HARTMAN & ASSOCIATES, INC.

Job Number: 99.0331.012

Included in this fax transmission is a copy of the Semi-Annual groundwater monitoring report with the exceedance table. The original report will follow via U.S. Mail.

COPIES	DATE	NO.	DESCRIPTION
1			Figure 3-13

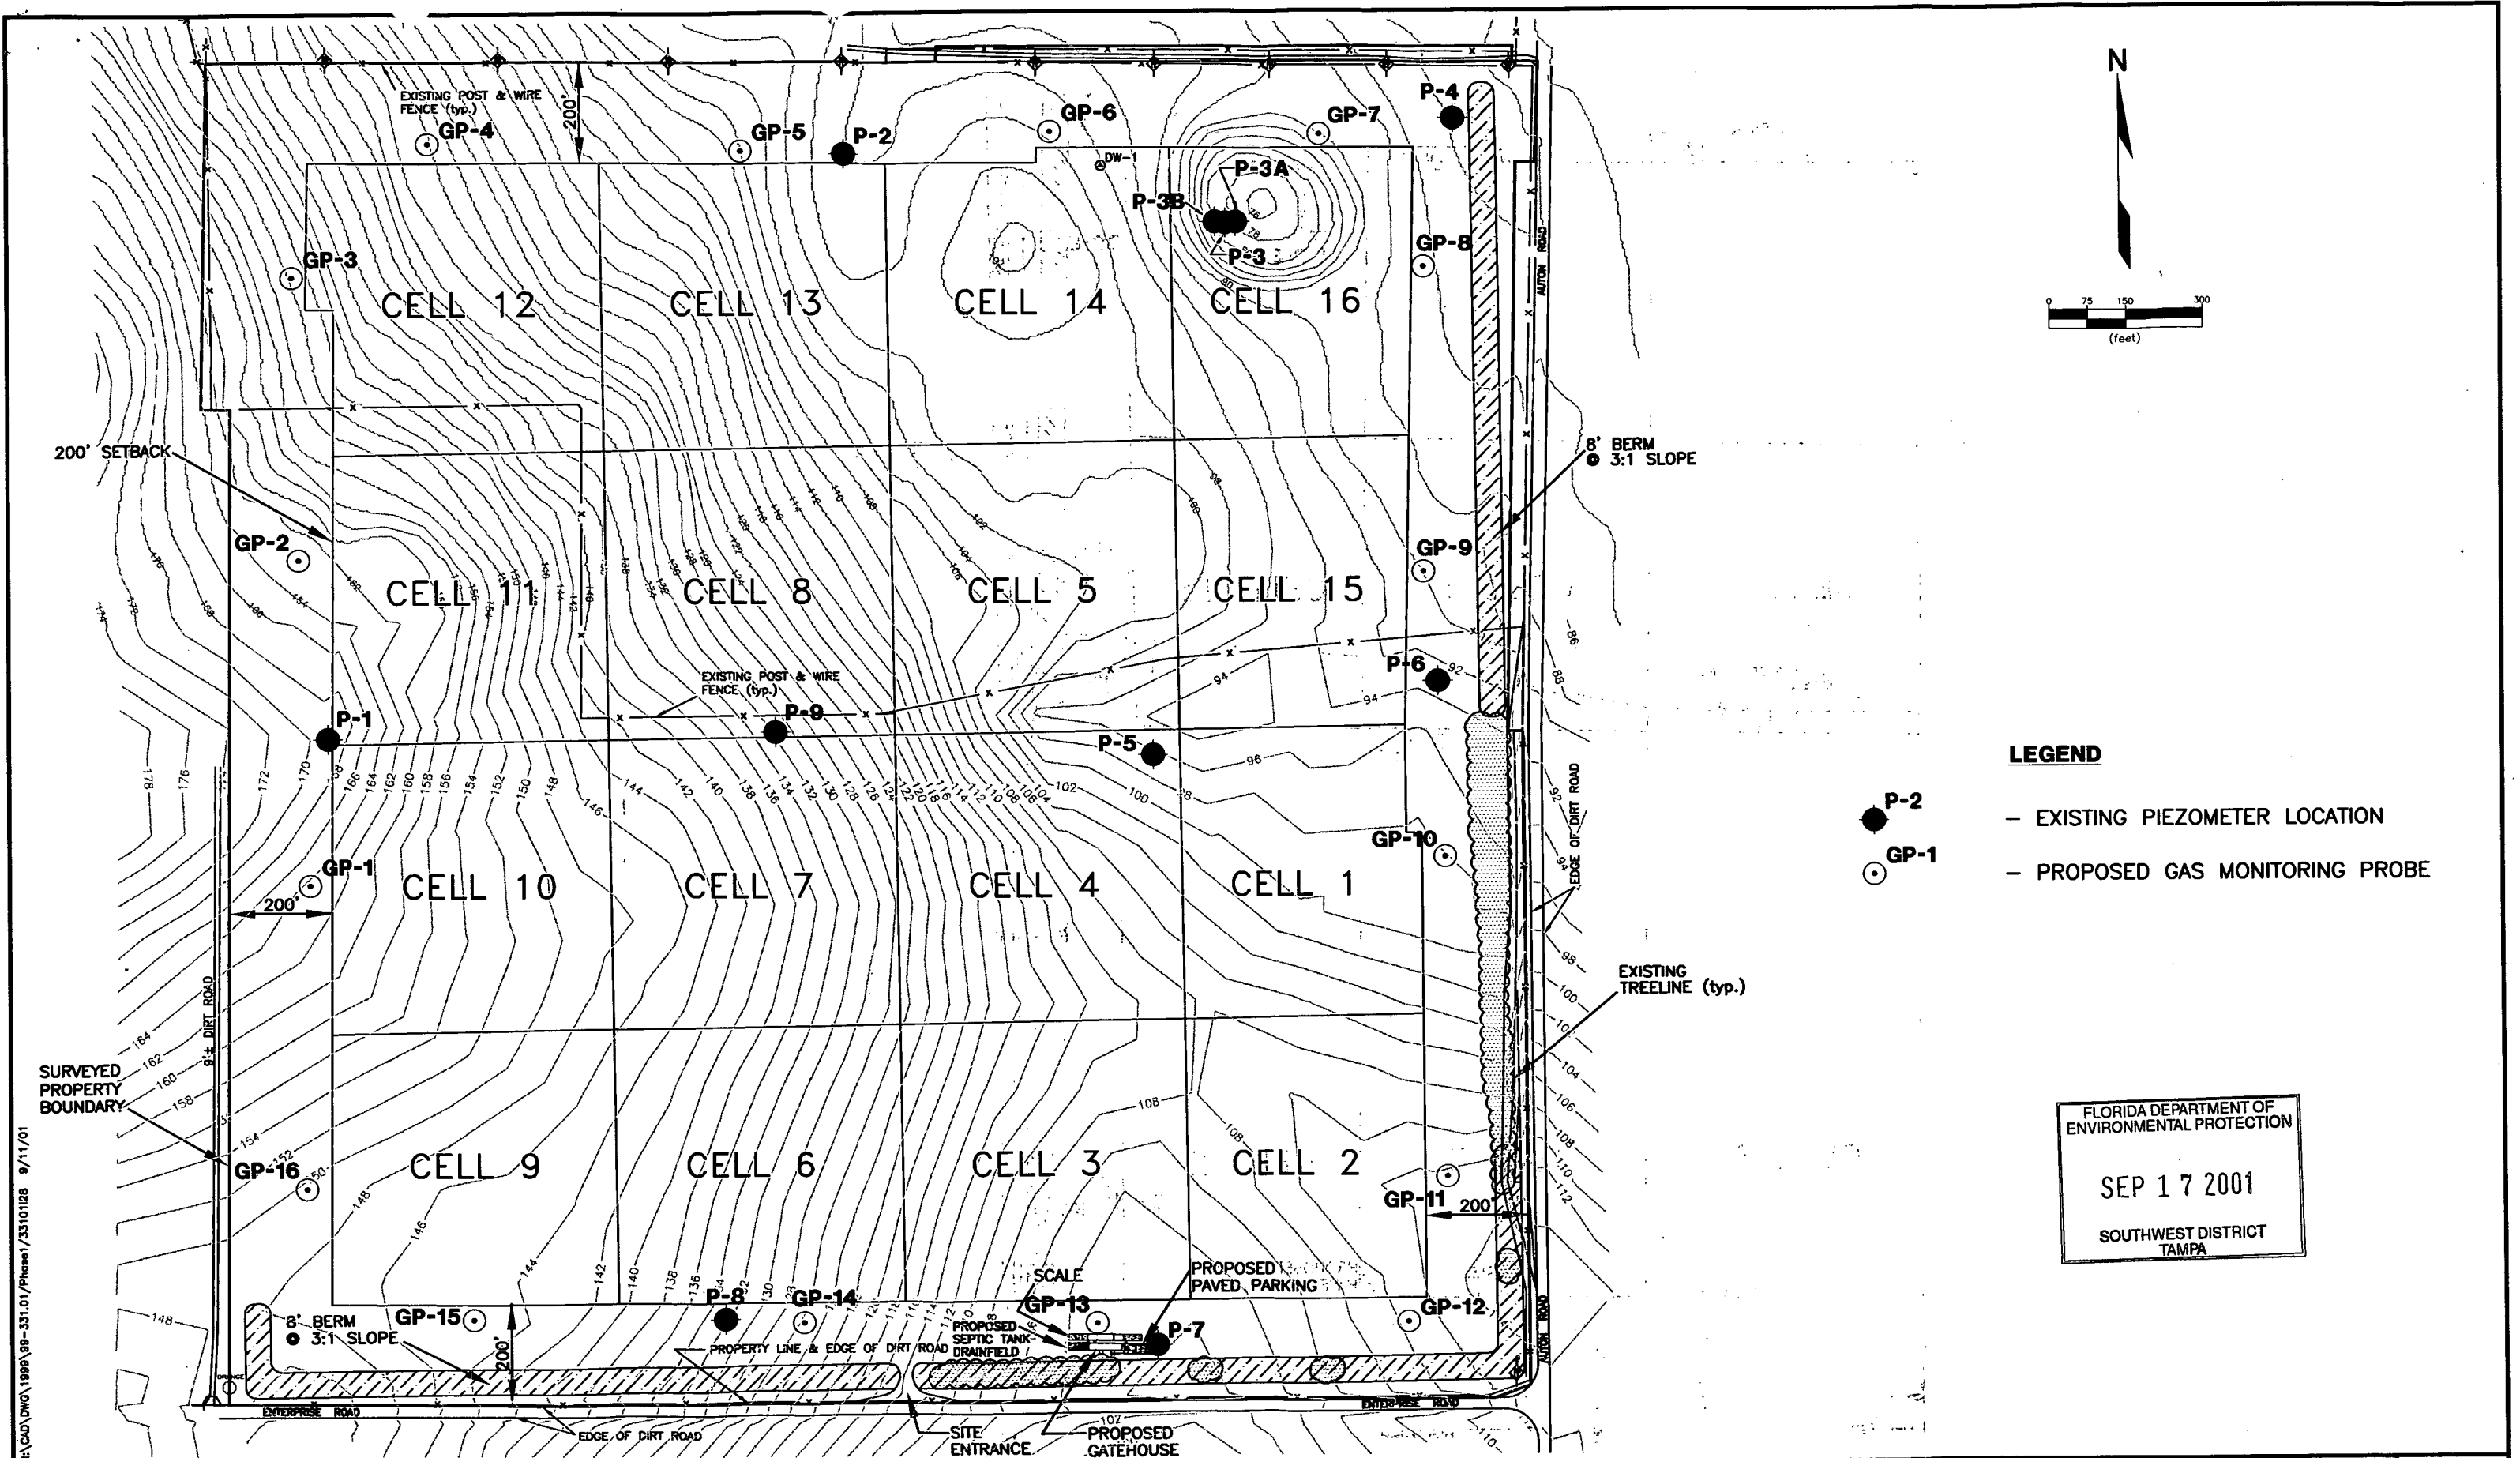
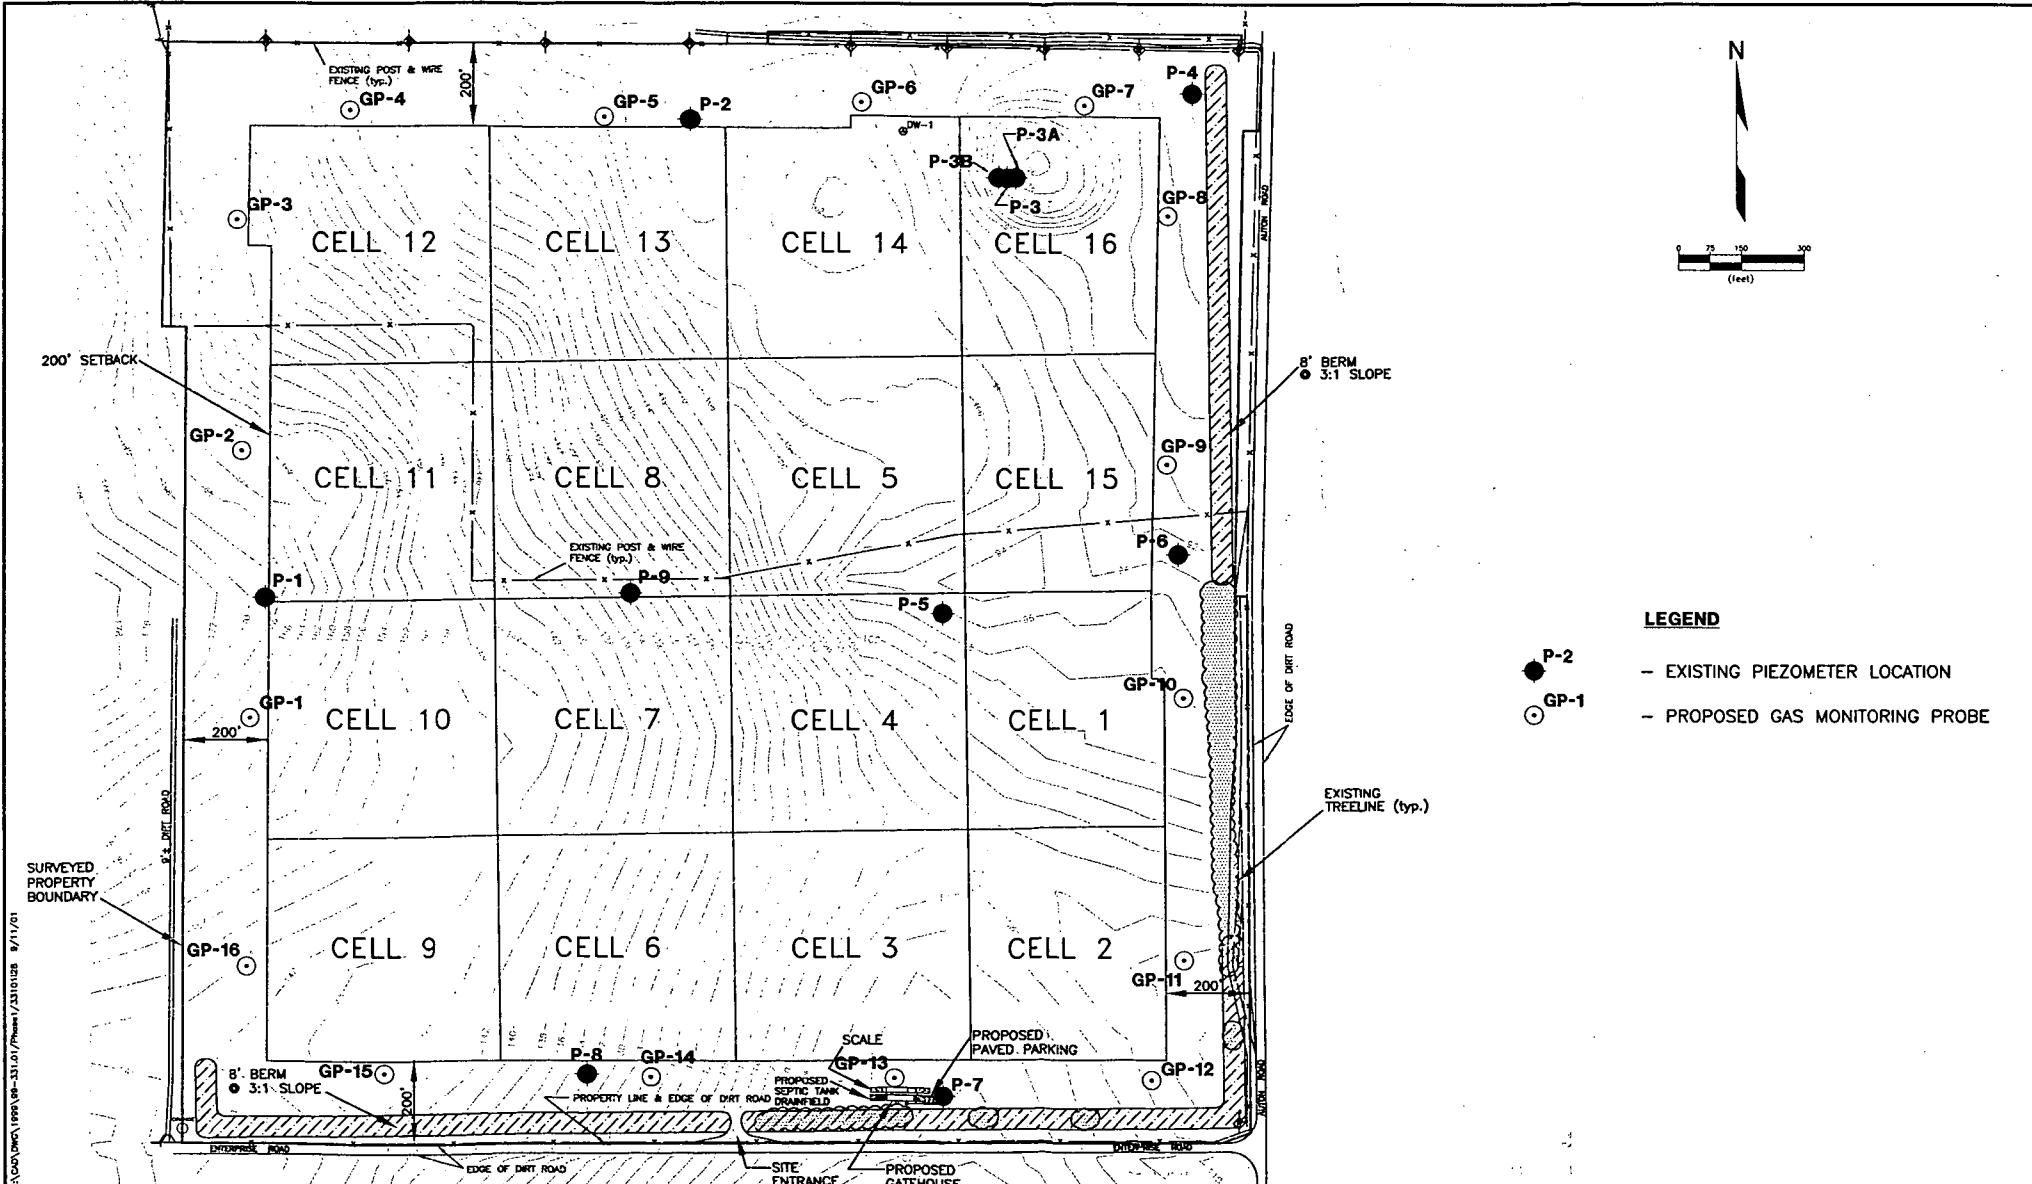
WE DISCUSSED HER FAX COMMENTS - 166 ATTRIBUTES
I REQUESTED A CORRECTED FIGURE 3-13
AND AGREED TO REVISE DRAFT
PERMITS TO ALLOW INSTALLATION OF
ONLY 6 GAS PROBES NOW.
